Contract No. T201200107.01
Federal Aid Project No. ESTP-N387(15)
HEP NCC, SR896 AND PORTER ROAD INTERSECTION IMPROVEMENT
New Castle County

Enclosed is Addendum No. 2 for the referenced contract consisting of the following:

1. Four (4) sheets, Construction Plans, sheets 4, 5, 8, and 19, revised, to be substituted for the same sheets in the Plan Set.

TYPICAL SECTIONS	SHEET NO.	5
	TOTAL SHTS.	32

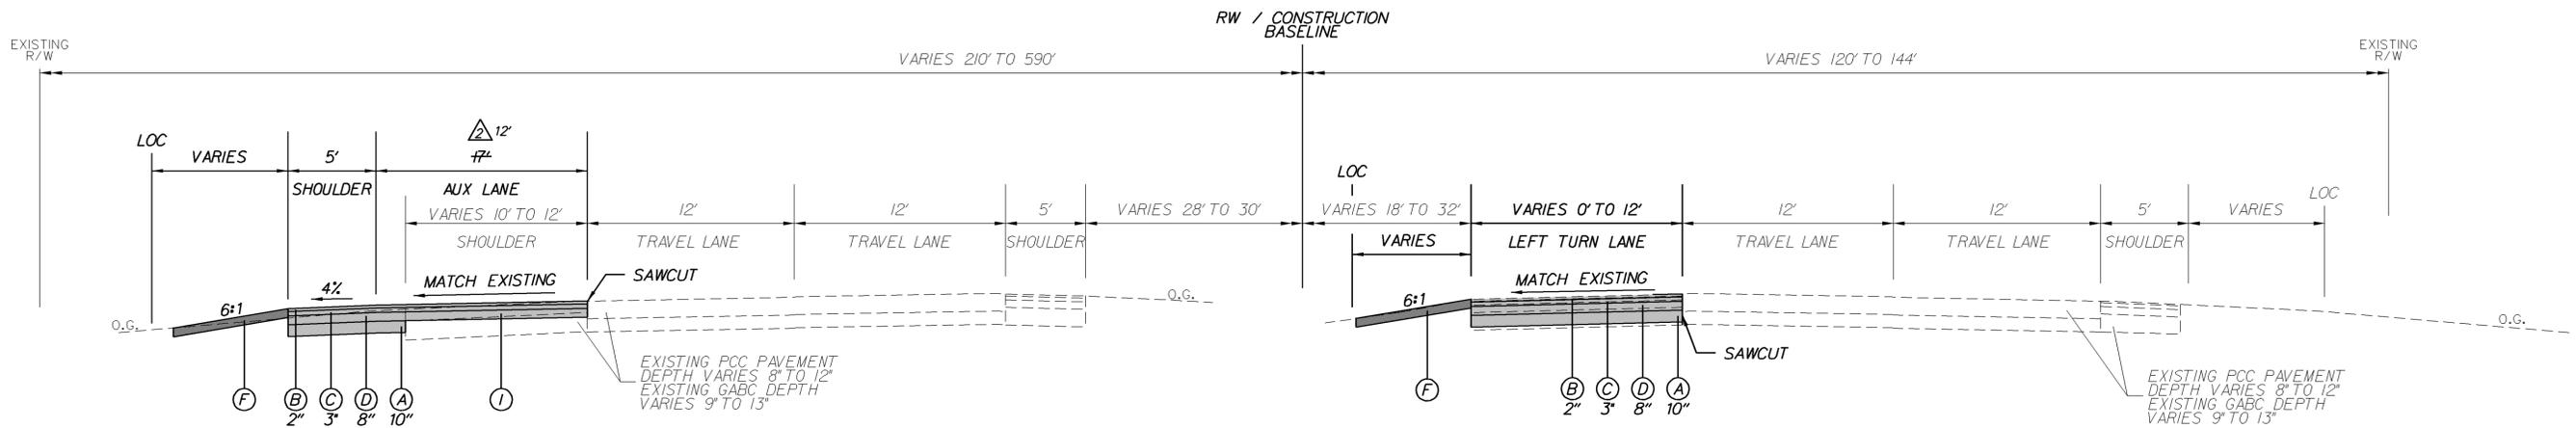
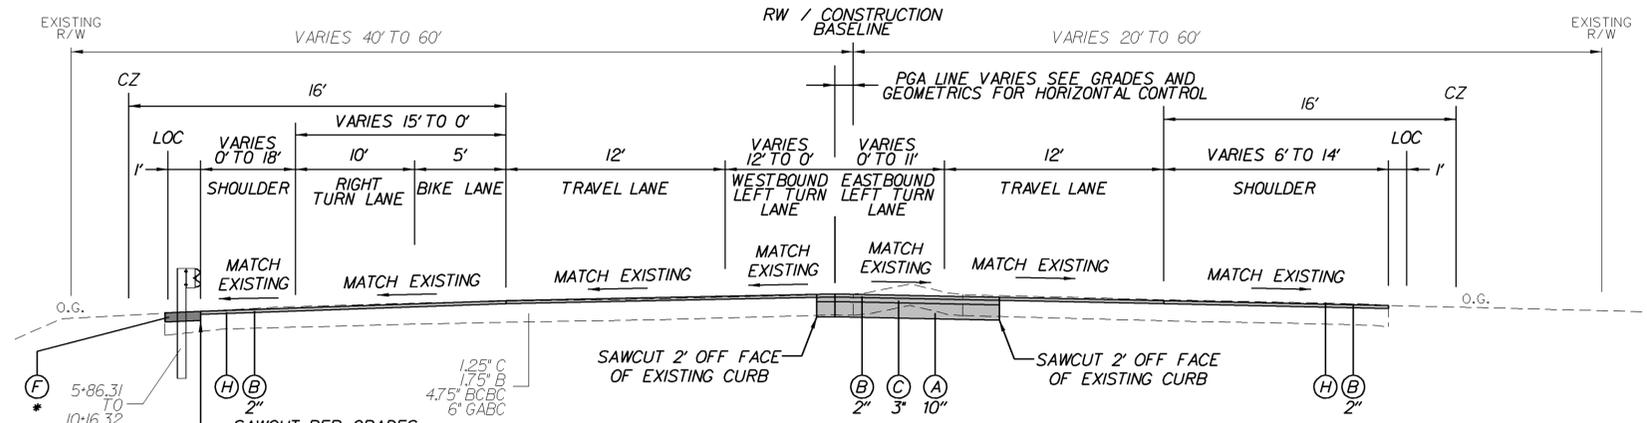
ADDENDUMS / REVISIONS
CHANGED SR 896 SOUTHBOUND AUX LANE WIDTH TO 12'

SHEET NO. 8
TOTAL SHTS. 32

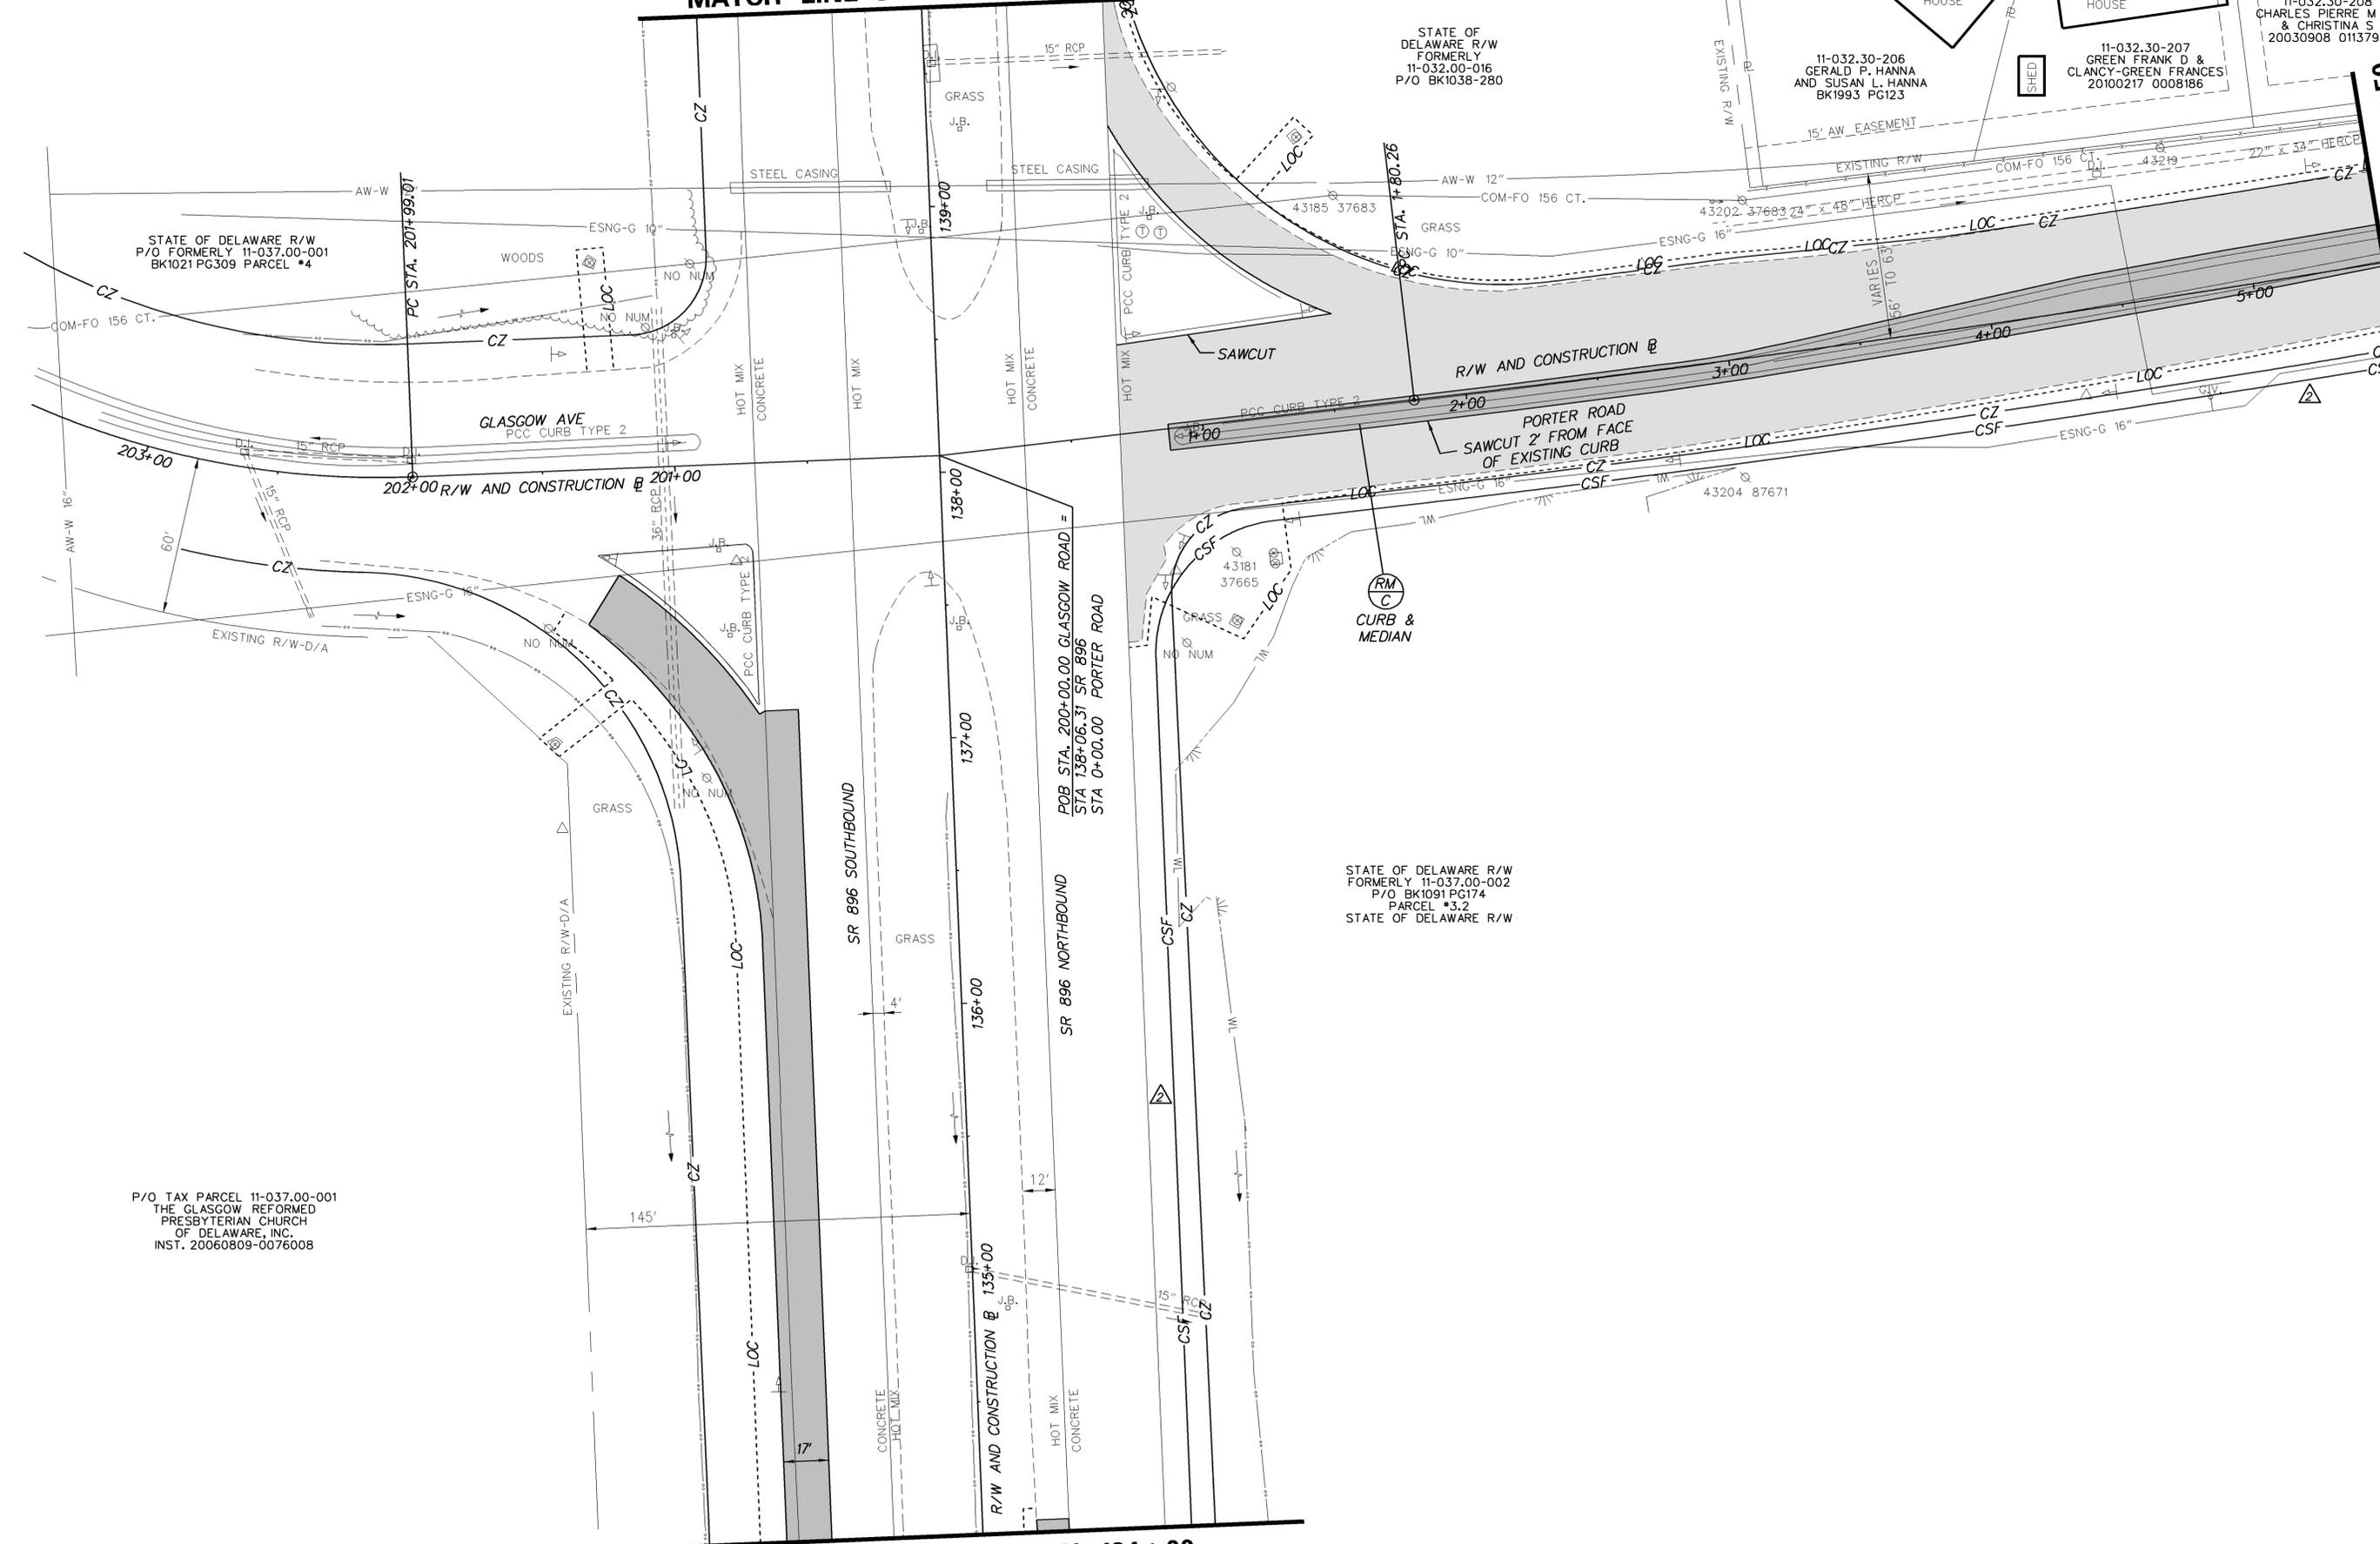
ADDENDUMS / REVISIONS	
△	CONSTRUCTION SAFETY FENCE ADDED

SHEET NO.	19
TOTAL SHTS.	32

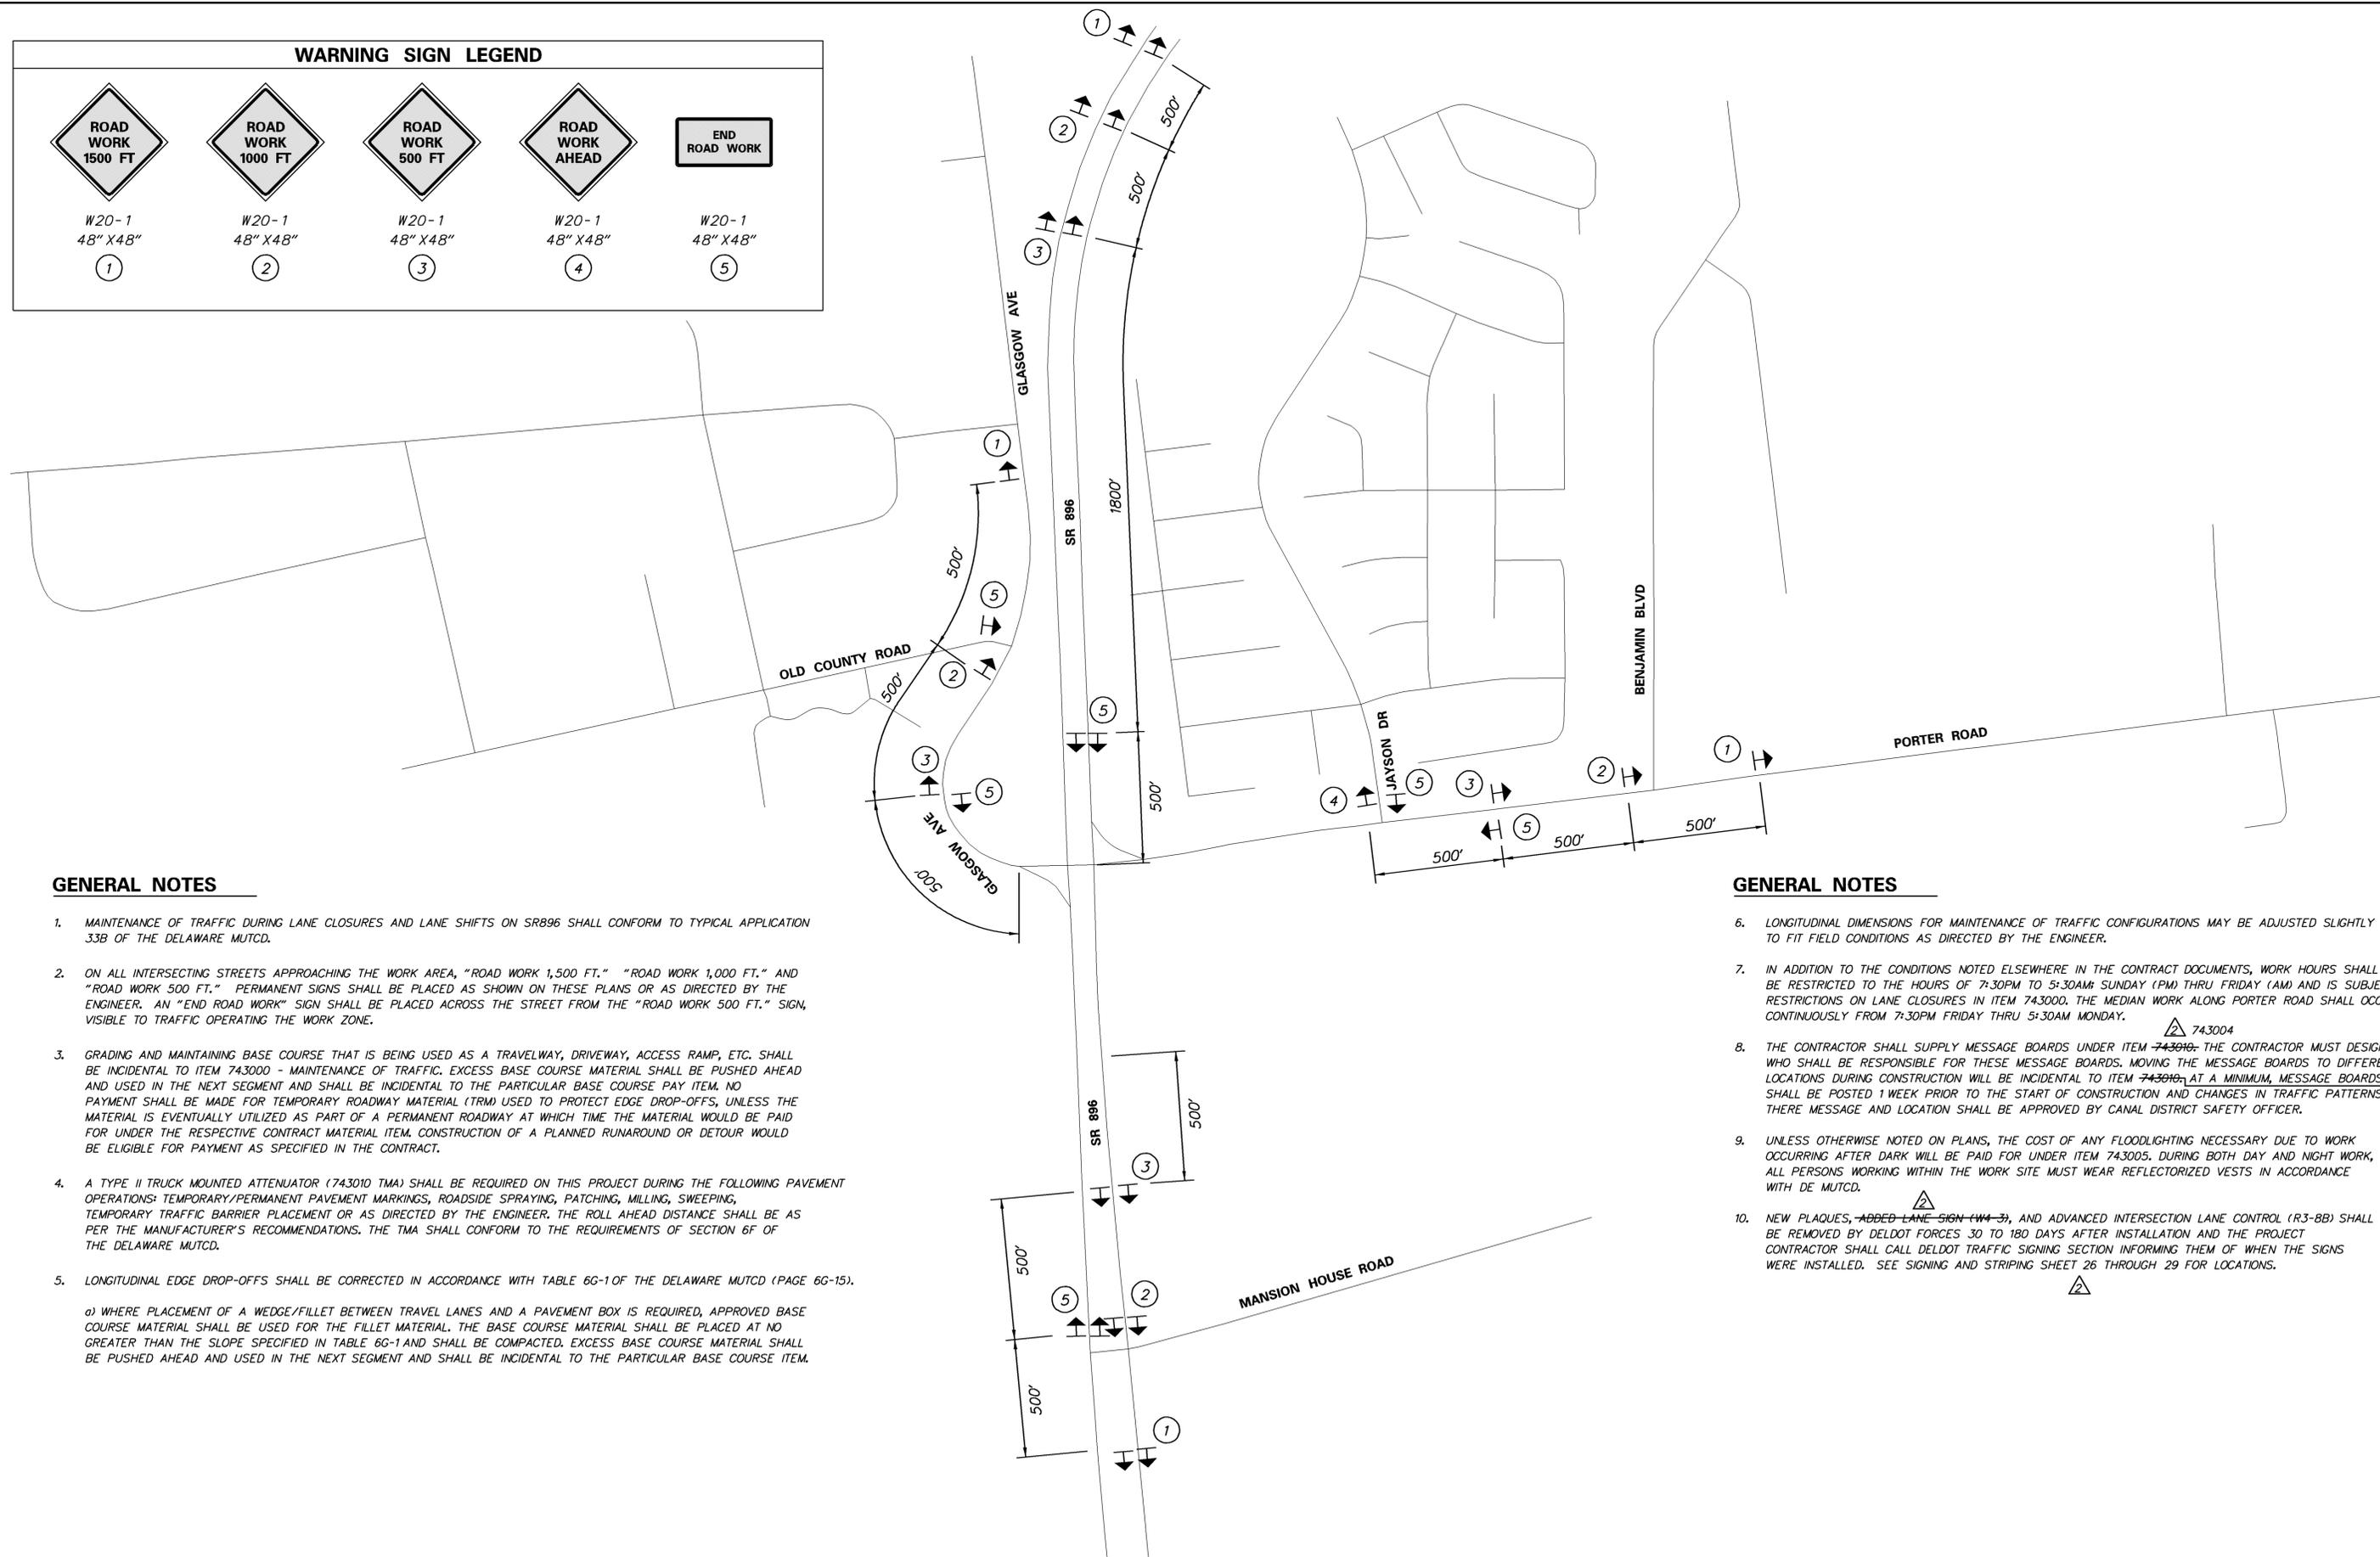
ADDENDUMS / REVISIONS	
	REVISED NOTES #8 & #10

8. THE CONTRACTOR SHALL SUPPLY MESSAGE BOARDS UNDER ITEM ~~743010~~. THE CONTRACTOR MUST DESIGNATE WHO SHALL BE RESPONSIBLE FOR THESE MESSAGE BOARDS. MOVING THE MESSAGE BOARDS TO DIFFERENT LOCATIONS DURING CONSTRUCTION WILL BE INCIDENTAL TO ITEM ~~743010~~. AT A MINIMUM, MESSAGE BOARDS SHALL BE POSTED 1 WEEK PRIOR TO THE START OF CONSTRUCTION AND CHANGES IN TRAFFIC PATTERNS. 743004 THERE MESSAGE AND LOCATION SHALL BE APPROVED BY CANAL DISTRICT SAFETY OFFICER.

10. NEW PLAQUES, ~~ADDED LANE SIGN (W4-3)~~, AND ADVANCED INTERSECTION LANE CONTROL (R3-8B) SHALL BE REMOVED BY DELDOT FORCES 30 TO 180 DAYS AFTER INSTALLATION AND THE PROJECT CONTRACTOR SHALL CALL DELDOT TRAFFIC SIGNING SECTION INFORMING THEM OF WHEN THE SIGNS WERE INSTALLED. SEE SIGNING AND STRIPING SHEET 26 THROUGH 29 FOR LOCATIONS.
